# LECKHAMPTON WITH WARDEN HILL NEIGHBOURHOOD DEVELOPMENT PLAN

Response on behalf of Miller Homes

JBB7795.C8323  
Final  
11 April 2023

Figure 6-1 Extent of flooding – Leckhampton (<https://check-long-term-flood-risk.service.gov.uk/map>)

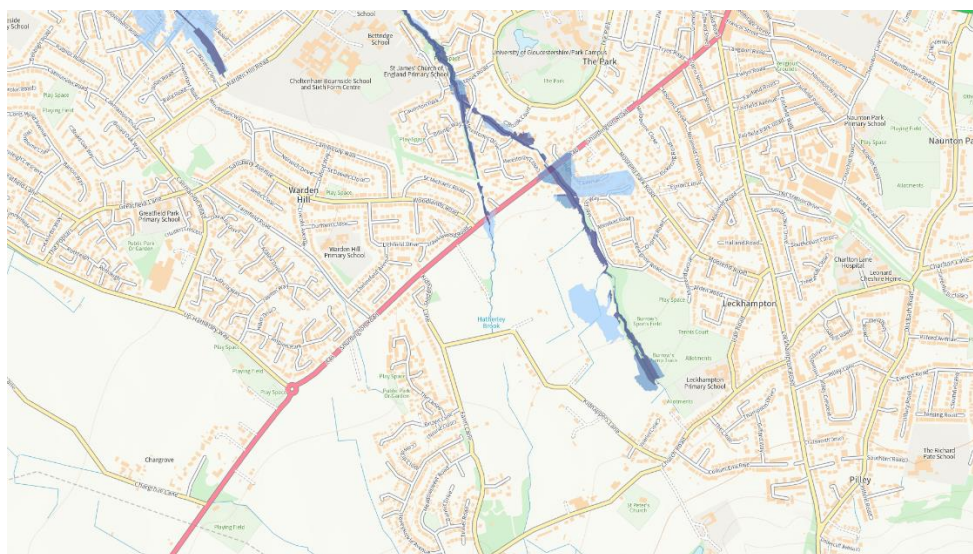
- 6.3 Area 6 largely comprises land within areas at risk of flooding and so would not constitute developable land on any reasonable assessment. RPS would also question whether the small areas ‘fingers’ extending in a north-westerly and easterly direction actually form part of Hatherley Brook or are at risk of flooding which is very narrow in extent, as can be seen in the extract below. This part of the policy has not properly been evidenced and justified.

- 6.4 On this basis, **the identification within Appendix 3 of Area 6 is not justified on the available evidence. No evidence has presented in the LWHNDP to justify any incursion of these protections in a lateral direction west or east to include land beyond Hatherley Brook corridor.**
- 6.5 Area 7 includes two parcels of land that are of particular interest to LWHPC and which have been specifically identified for protection and enhancement in the LWHNDP under Policy LWH5. The full extent of these areas is shown in Appendix 3.
